Runkle Canyon Response Plan
Simi Valley, California

December 4, 2008

This response plan addresses the requests made by DTSC upon the completion of its review of Runkle Canyon documents pursuant to the Standard Agreement under the California Land Reuse and Revitalization Act (CLRRA). In a letter to representatives of Runkle Canyon, LLC on October 17, 2008, DTSC requested that Runkle Canyon, LLC prepare a response plan to address the following issues:

Figure 1. Sampling area and sample locations for the non-residential Runkle Canyon area.

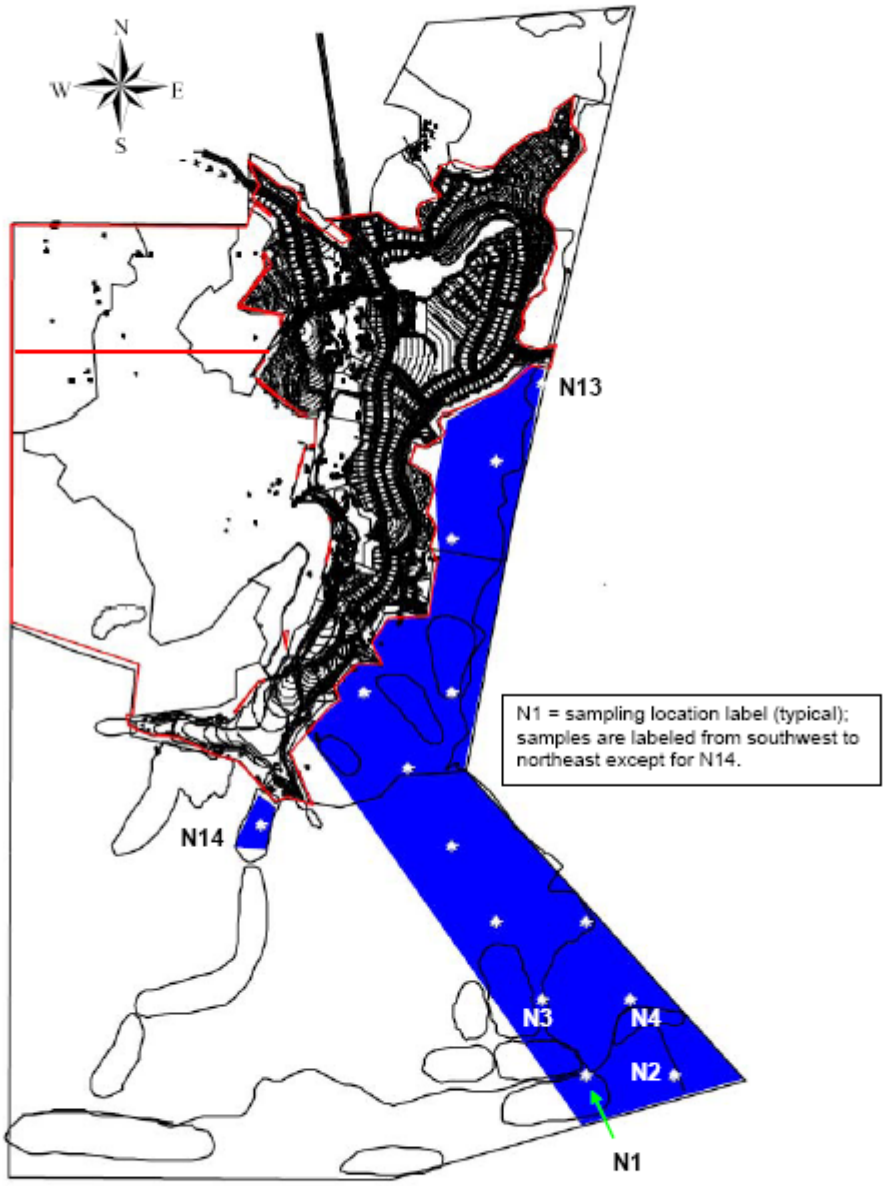
> *Runkle Canyon, LLC should consider including provisions for additional radionuclide testing in the Response Plan. This aspect of the Response Plan should at a minimum, specify sample locations, the number of samples to be collected at each location, the analytical methods to be used, the detection limits to be used, and a justification for the proposed level of sampling.*

Response. In accordance with DTSC's request, Runkle Canyon, LLC will agree to perform additional ^{90}Sr soil sampling in those nonresidential areas of Runkle Canyon closest to the SSFL. Attachment A to this response plan is the soil sampling plan for that area and includes all of the requested information. In summary, this sampling area is considered MARSSIM Class 3 and the

DCGL is set at 1.7 picocuries per gram, which corresponds to an annual risk of 1×10^{-7} based on the no-food suburban exposure scenario in NCRP Report 129 (NCRP 1999). Using the MARSSIM methodology, 14 sample locations were randomly selected within a triangular grid over the sampling area that was generated by the VSP software program[5]. Analytical capability will have a detection limit of 0.05 picocurie per gram or lower for ^{90}Sr, which is similar to that for the 2007 sampling. Upon request Runkle Canyon, LLC will collect split soil samples and provide to DTSC for analysis of ^{90}Sr.

area was included to the west of the main sampling area and directly south of the previously sampled residential area as shown in Figure 1. This area will be the location of sample N14 as noted in Table 2.
